MISSION REPORT / RAPPORT DE MISSION

Stonehenge, Avebury and Associated Sites (United Kingdom of Great Britain and Northern Ireland) (373bis)

Report on the joint World Heritage Centre / ICOMOS Advisory Mission to Stonehenge, Avebury and Associated sites

31 January – 3 February 2017

Fig. 6.4.3 - Western portal site at 1 to 30.000 - 2016 by Highways England

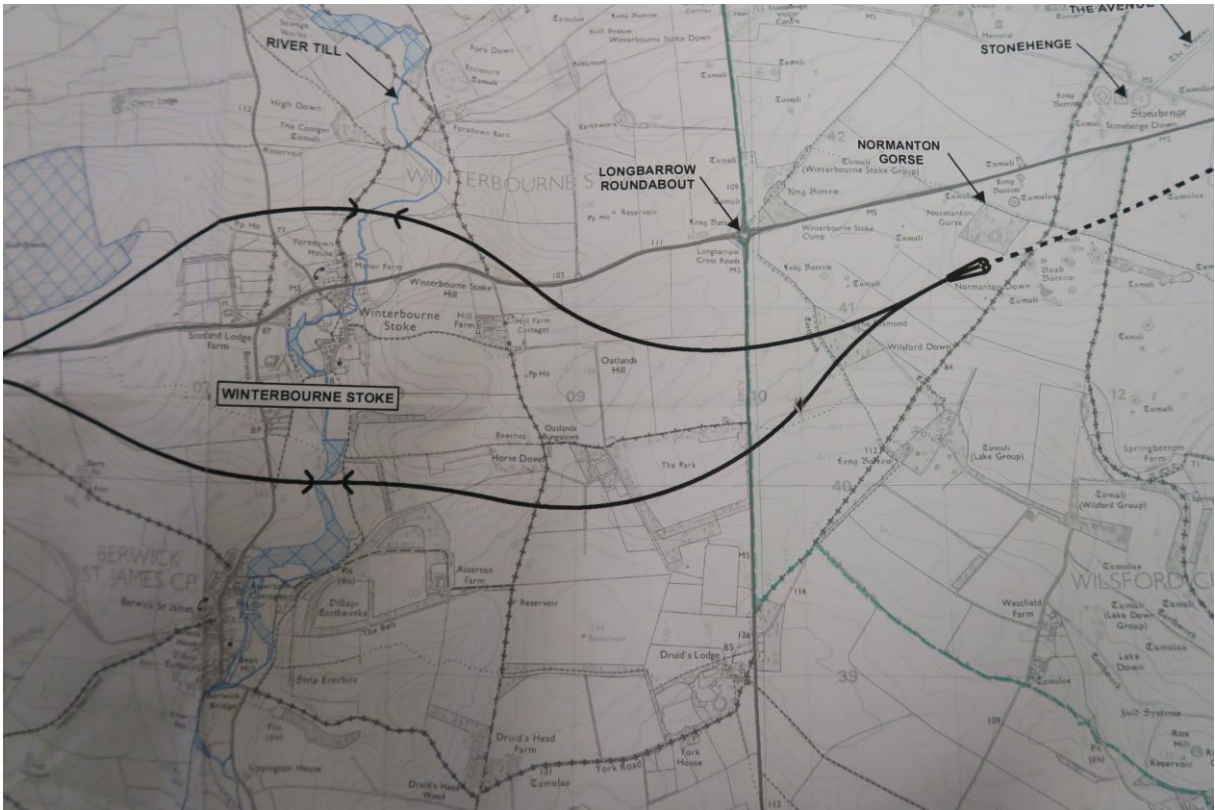
The SP and its heritage bodies will nonetheless need to remain particularly vigilant, as further decisions are taken and plans proceed, that a full heritage impact assessment is carried out in the area, and that both the portal and its access route and construction infrastructure have no adverse effect on heritage assets that contribute to OUV. This needs to be emphasised because the area to the east of the Avenue within the WH property contains several heritage assets, some well known such as Vespasian's Camp, others in the course of being investigated, such as Blick Mead (Mesolithic). Concerns about these heritage assets have already been expressed by respondents to the public consultation.
